CITY OF BOULDER
PLANNING BOARD MEETING AGENDA
DATE: June 2, 2016
TIME: 6 p.m.
PLACE: 1777 Broadway, Council Chambers

**CITY OF BOULDER
PLANNING BOARD AGENDA ITEM**

Project Phase	
RE: SITE REVIEW	
SUBMITTAL COMMENTS	
Sheet Title	SITE PLAN 2
Sheet Number	A102

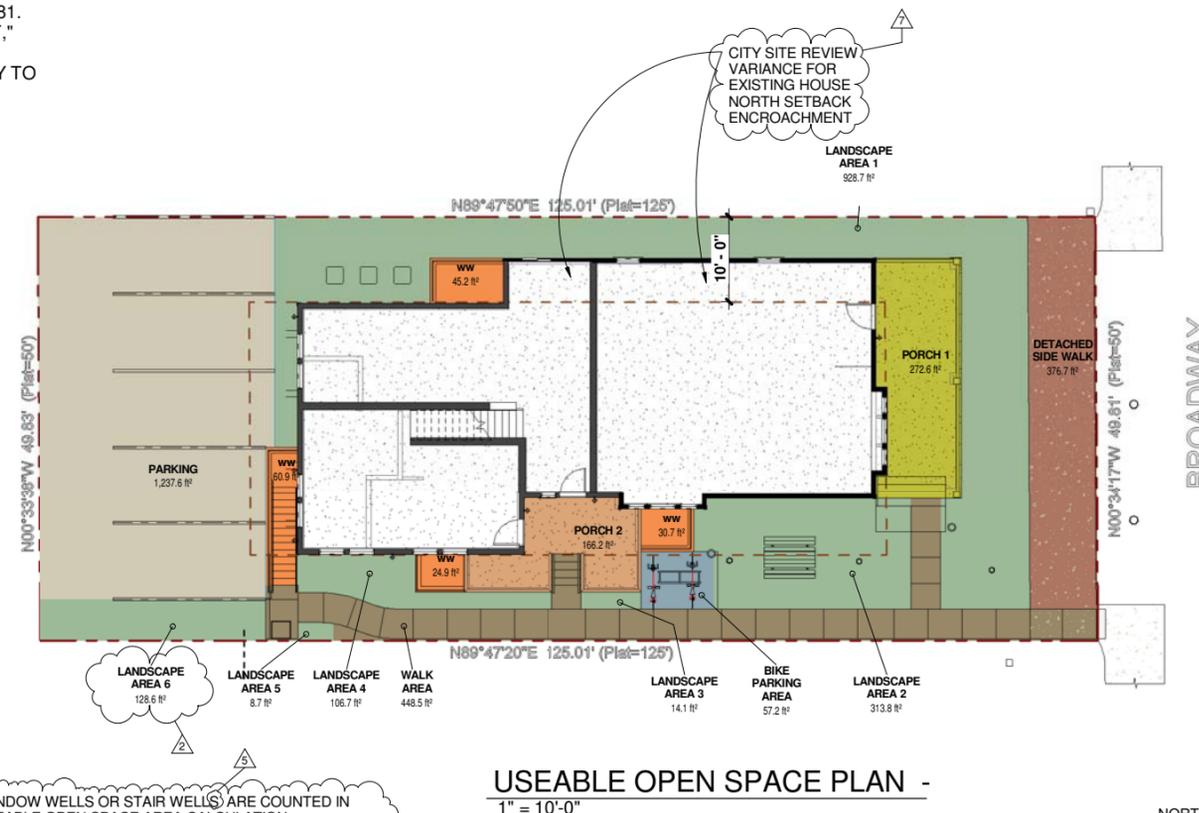
6. Per open space prohibitions (9-9-11), planting beds under 24 inches in width do not contribute to open space. Sheet A102 indicates that the beds south of the porch are included. Please remove them from the calculation or adjust the walkway, building footprint, etc. to meet the minimum width.

LANDSCAPE PLAN

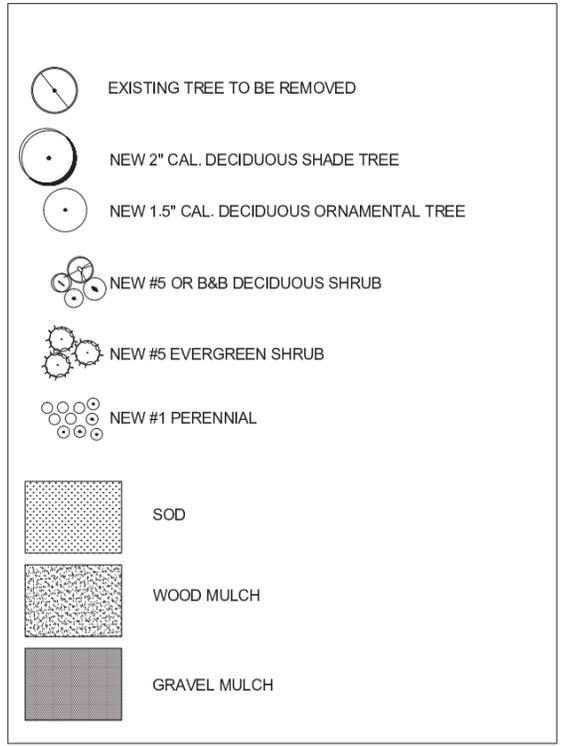
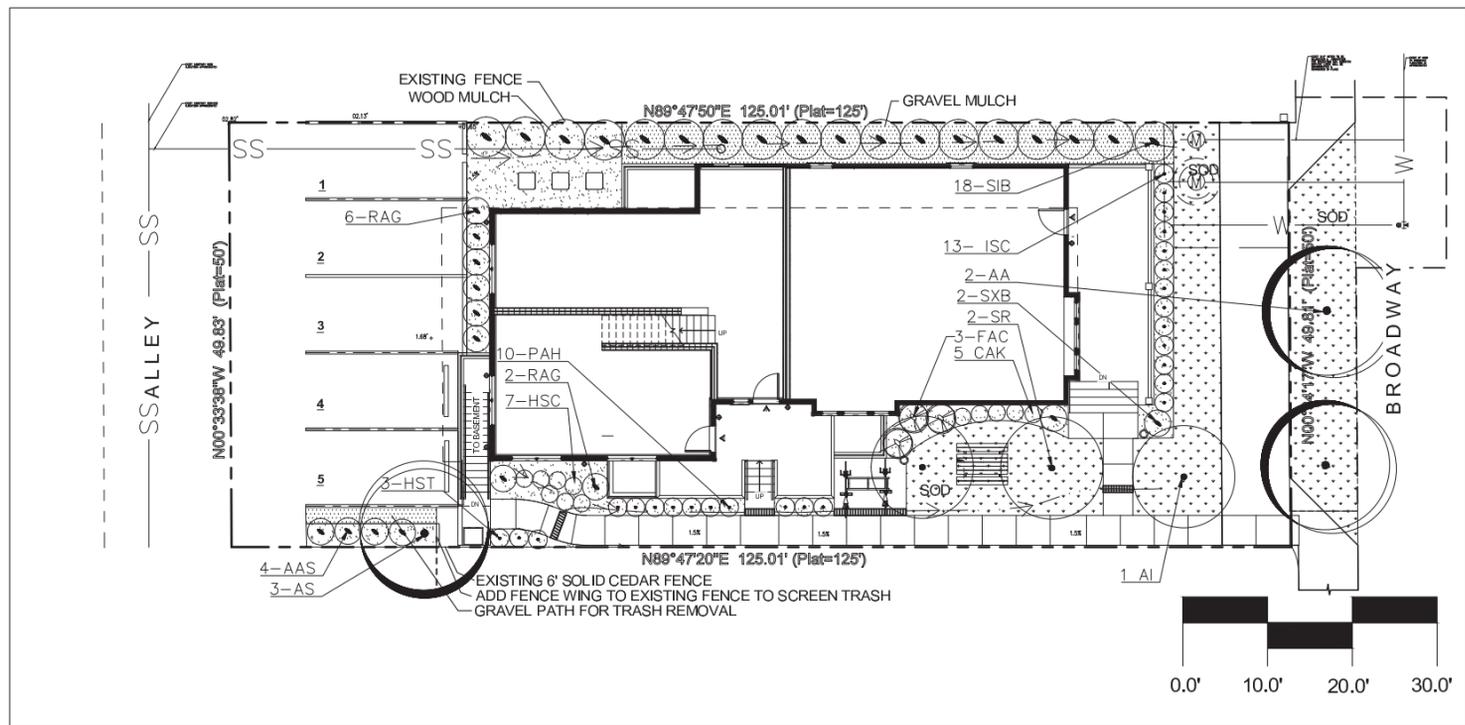
8. The existing blue spruce in the front yard setback is private and should be evaluated by a licensed arborist, not the city forester. Please update the note on sheet L-2 and provide any information about it preservation or removal.
